Point Beach Nuclear Plant, Units 1 and 2
Dockets 50-266 and 50-301
Renewed License Nos. DPR-24 and DPR-27

License Amendment Request 261, Supplement 4
Extended Power Uprate

LICENSE AMENDMENT REQUEST 261, SUPPLEMENT 4 EXTENDED POWER UPRATE

TRAIN "B" DISTRIBUTION SYSTEM VOLTAGES

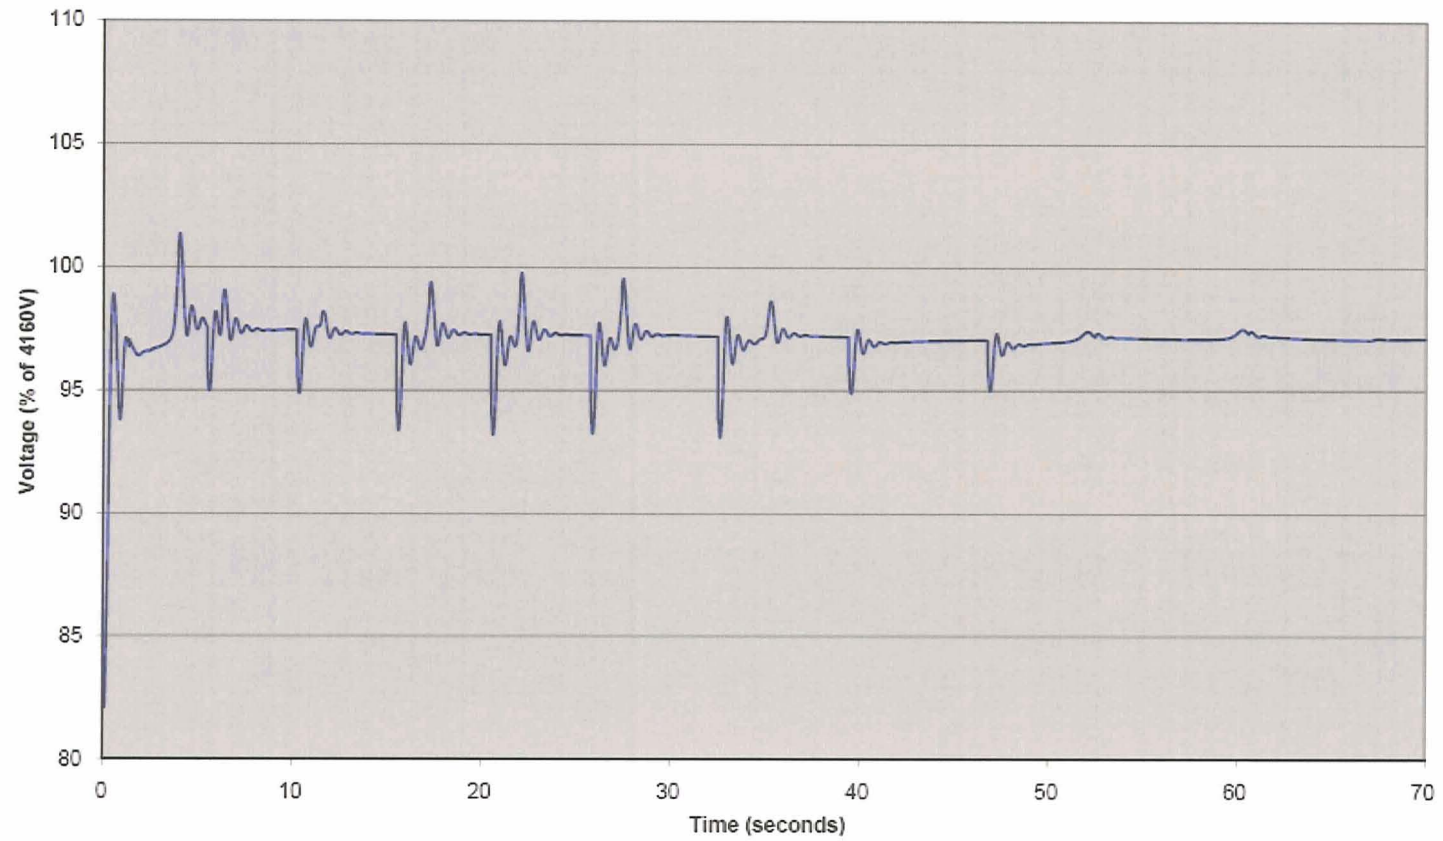
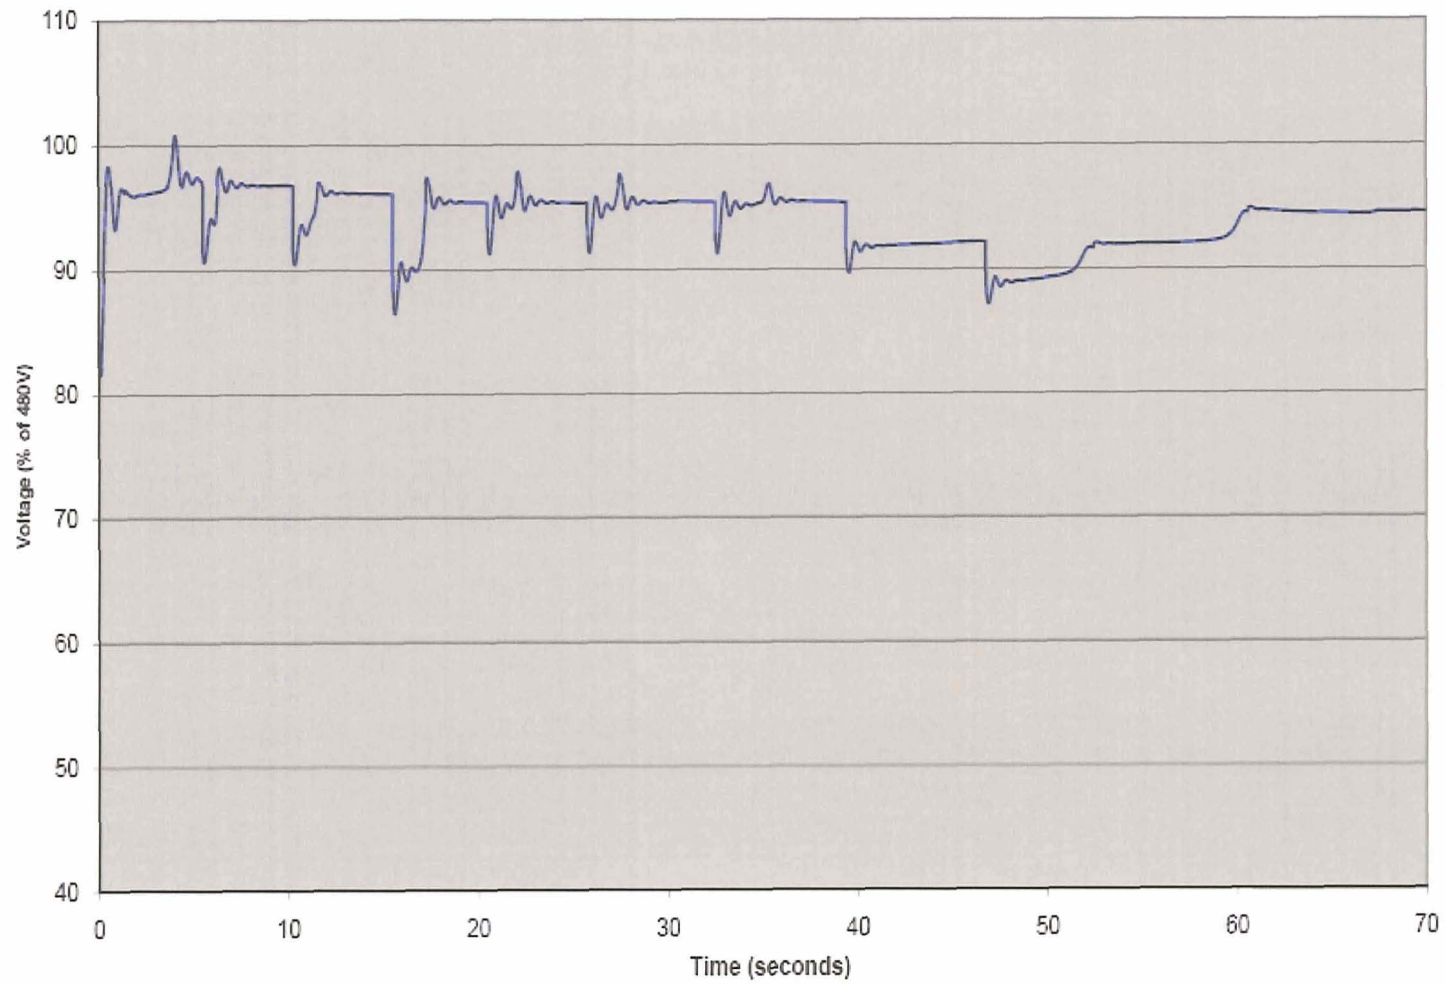
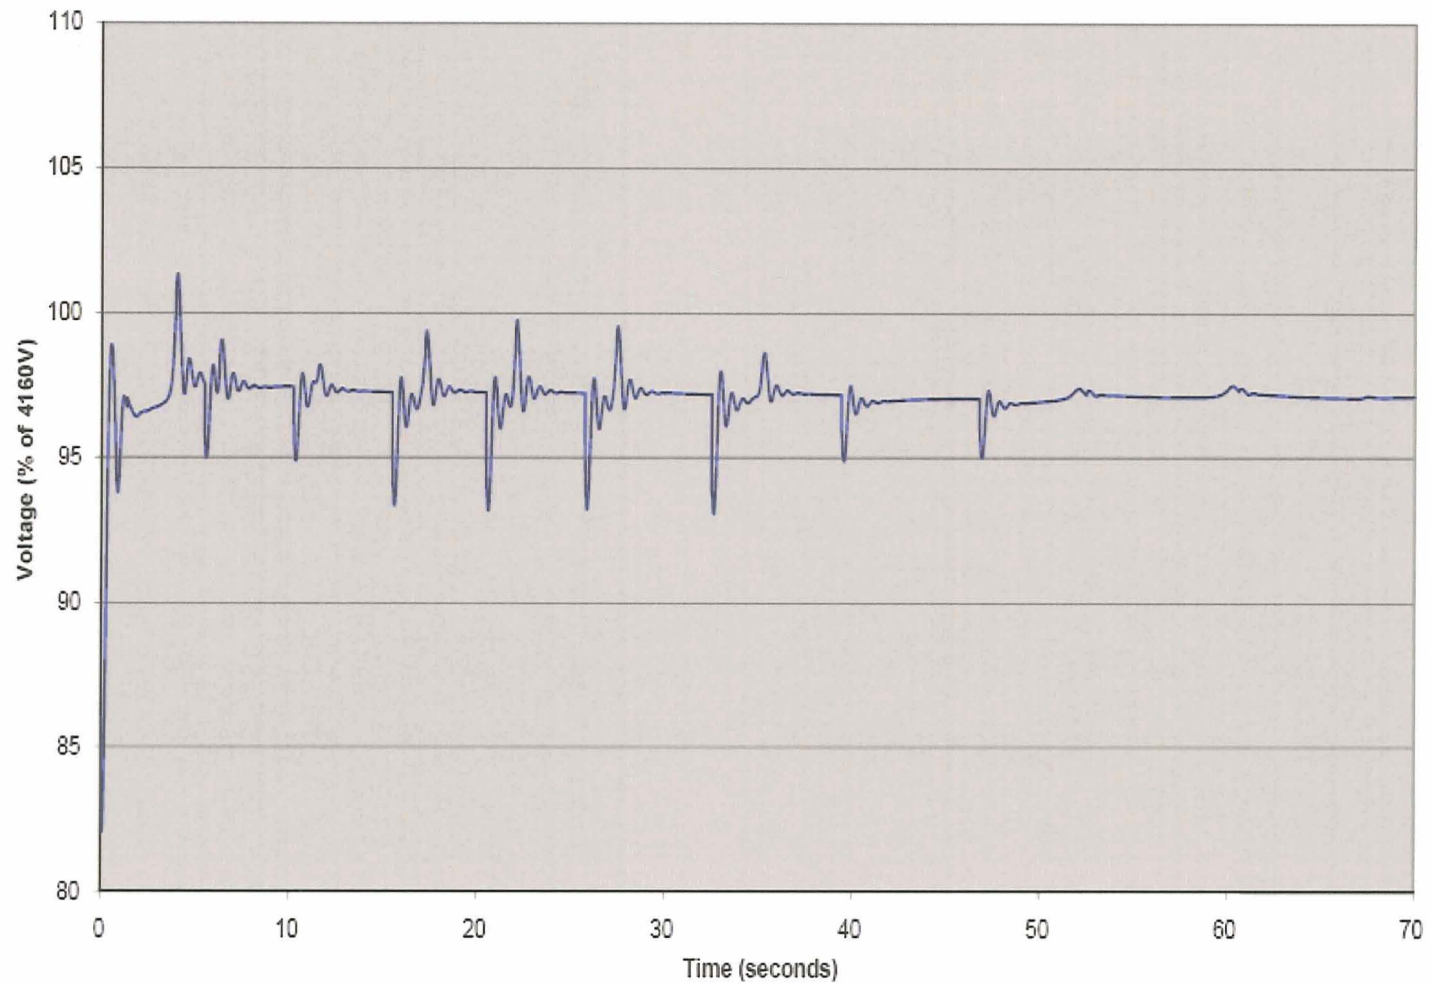
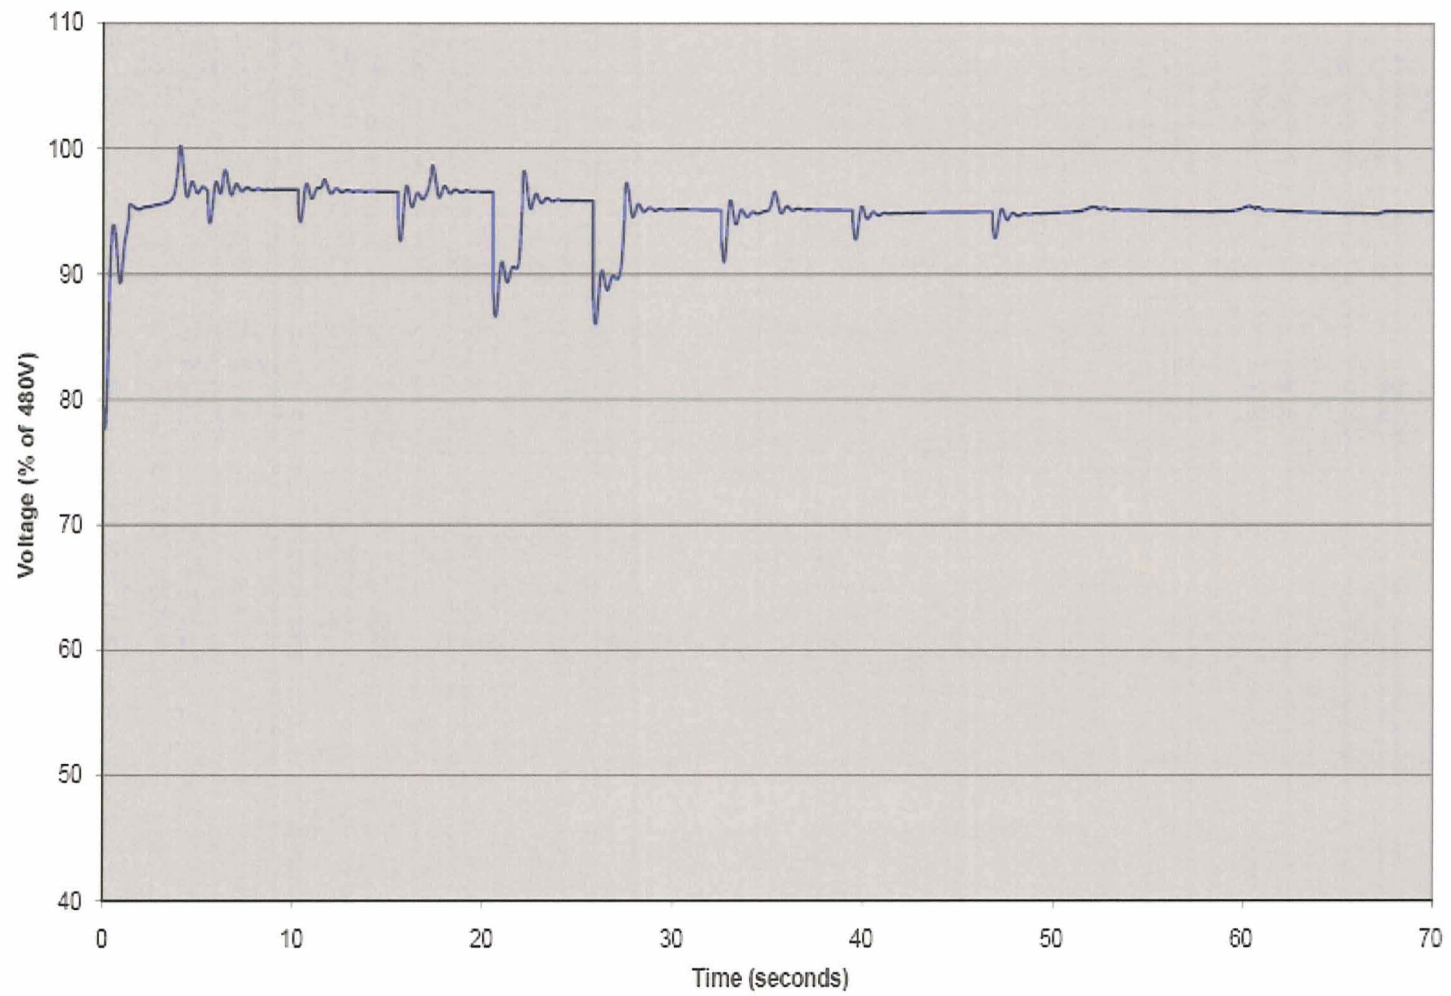
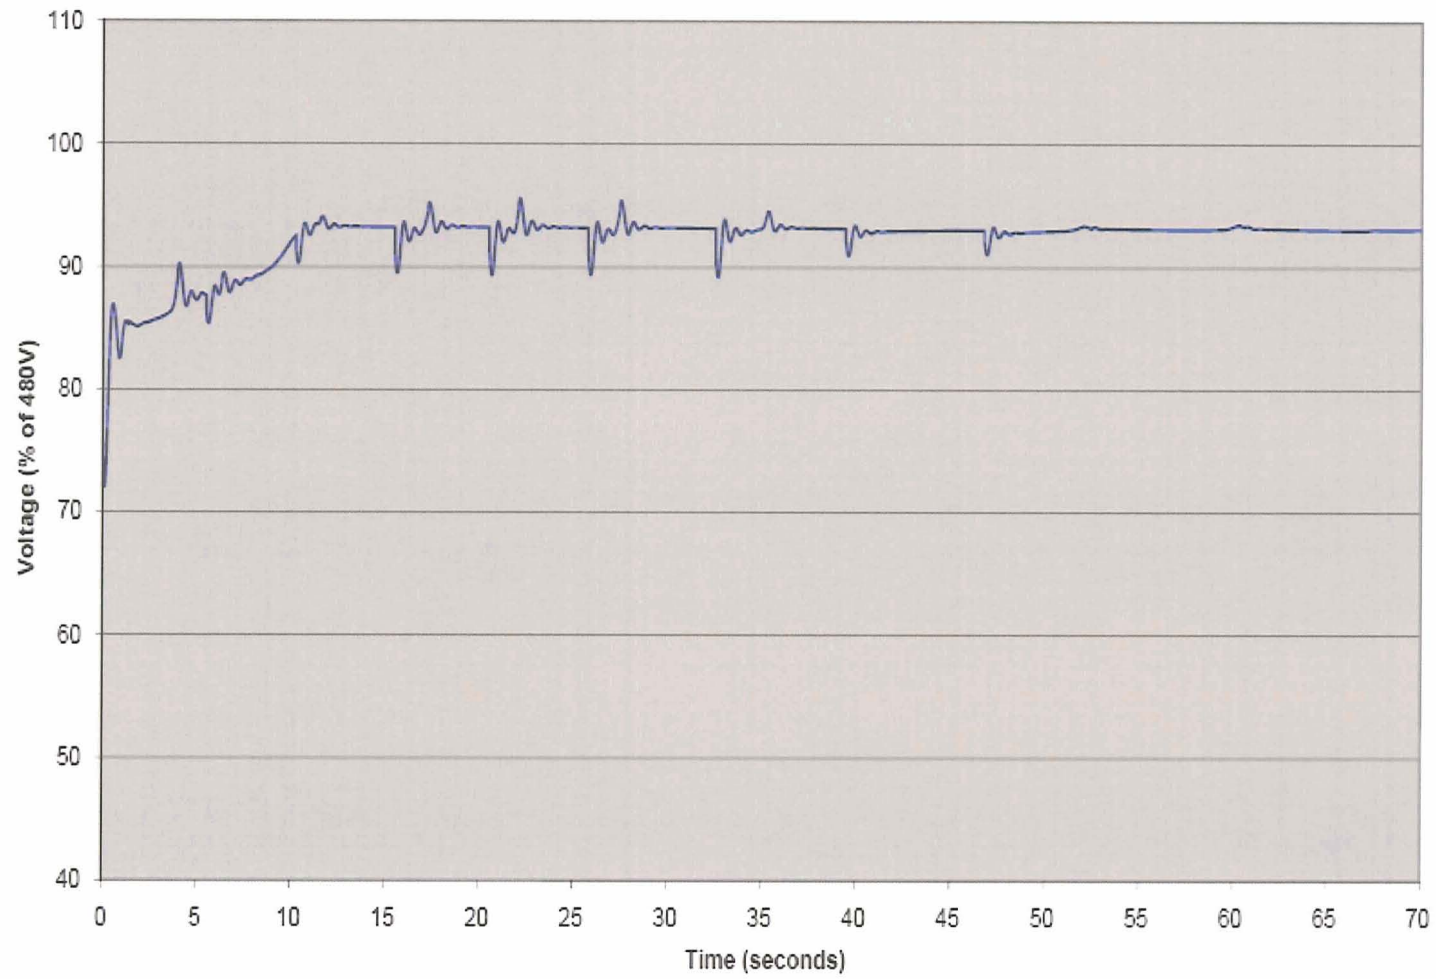
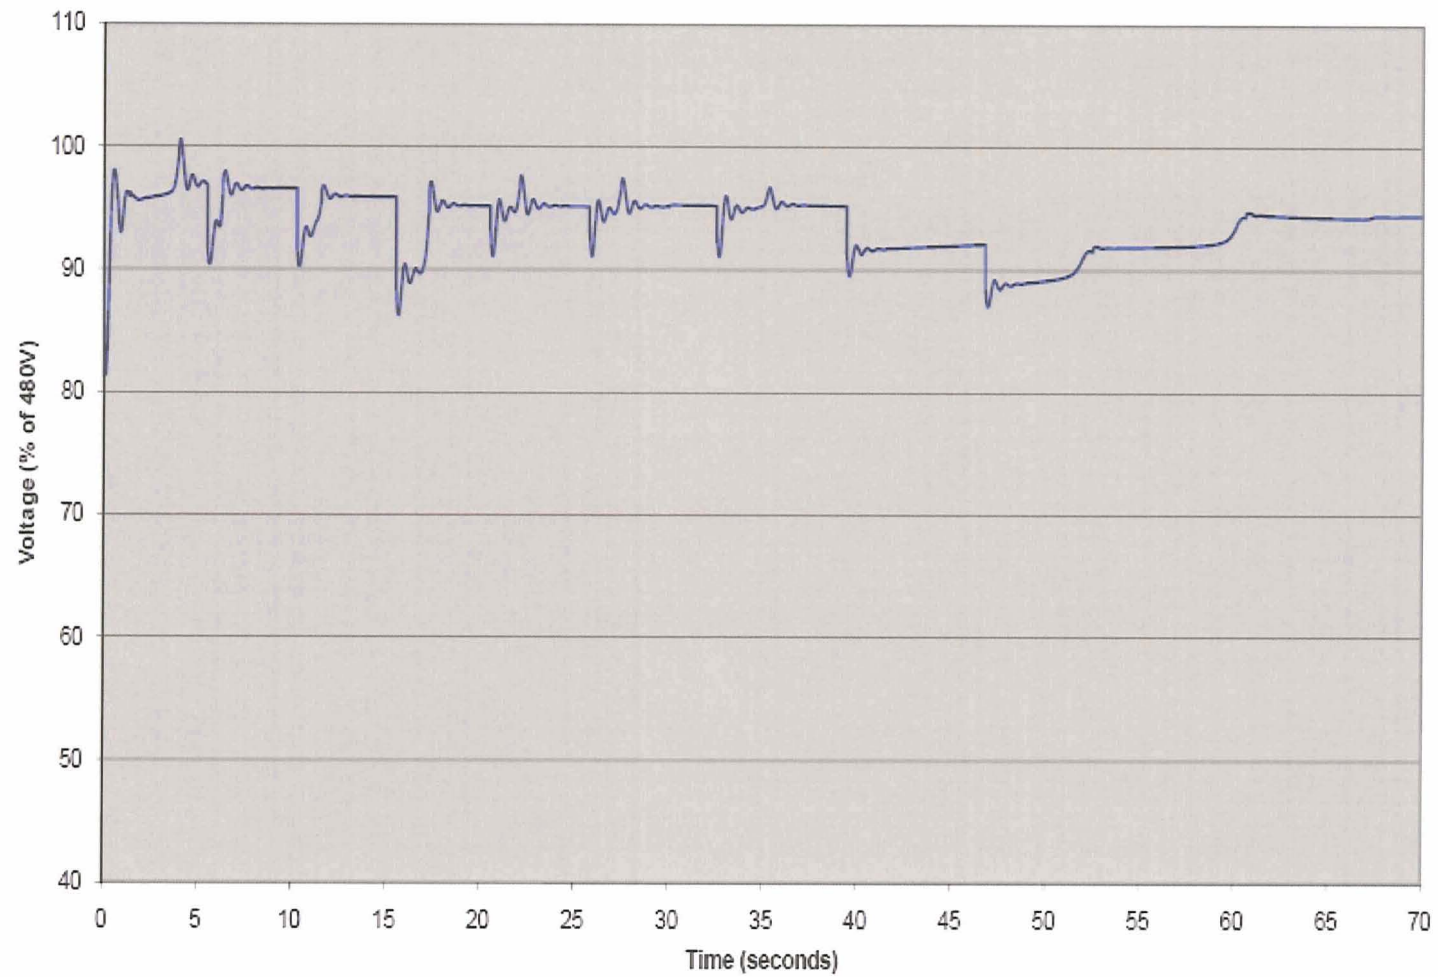
In response to staff's request for additional information (RAI) dated August 26, 2009, regarding the emergency diesel generator (EDG) voltage dip below the acceptance limit of 75 percent nominal voltage during motor start, the licensee stated that the EDGs are capable of starting safeguard loads, and the voltage recovers quickly to the acceptable level. Based on staff's review of the dynamic loading calculations, the staff notes that under certain loading conditions for Train "A" EDG, the frequency is outside 2 percent margin, the worst-case voltage dip is 45-48 percent and the voltage overshoot is 129.5 percent. Train "A" voltage and frequency variations are outside the industry accepted standards and guidance. Provide detailed analyses regarding the downstream effects on components such as contactors, control fuses, inverters, battery chargers, solenoids, motor-operated valves, solid state devices, etc., and the basis to show that all required loads will start and continue to run with sufficient margins after accounting for any uncertainties. Provide justification for the performance capabilities of the EDG "A" regulator and excitation systems to support shutdown equipment within design-basis requirements during a design-basis accident. The staff notes that Train "B" EDG bus voltages remain above 75 percent of nominal voltage, consistent with NRC Regulatory Guide (RG) 1.9, throughout the motor starting sequence in all postulated loading conditions. Provide a summary of all bus voltages for the 'B' train distribution system.

Attachment 5 provides a summary of bus voltages for the "B" train distribution system for the above large break LOCA design basis ETAP cases.
